American Certification Body Inc.  
6731 Whittier Ave, C110, McLean, VA 22101

RE: Brady Corporation

FCC ID: NUC-BC1000  
IC: 3287A-BC1000

ATCB021484

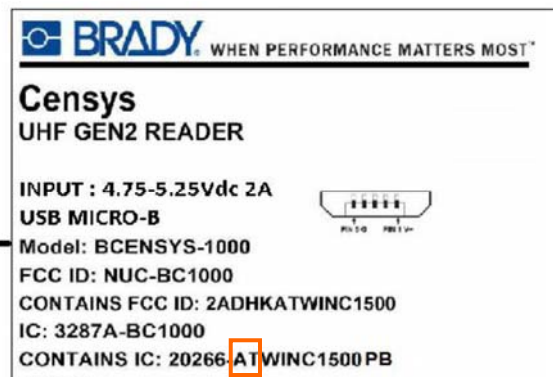
- 1) I hate to bear bad news, but it seems the labeling of the additional module from the most recent uploads just provided (Manual, Internal Photos, and Final Host Labeling) still is incorrect. If the information as cited is from a production version, it still seems to have a problem. The IC ID Number still does not match (there is a preceding AT that was not included on the certification number):  
Internal Photos:

Manual:

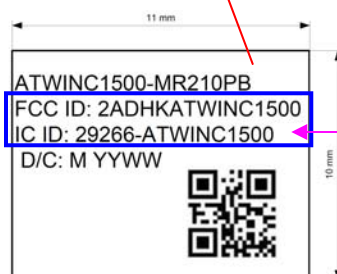
CONTAINS FCC ID: 2ADHKATWINC1500  
CONTAINS IC: 20266-ATWINC1500PB

While the FCC site shows the "AT" – Ultimately when certified for IC, the "AT" was not included as verified on the IC site above. Note that while the FCC site may unintentionally hold some of the IC information for a filing, is not the definitive "go-to" location for IC information as this may have potentially changed in the process of IC review/submittal.
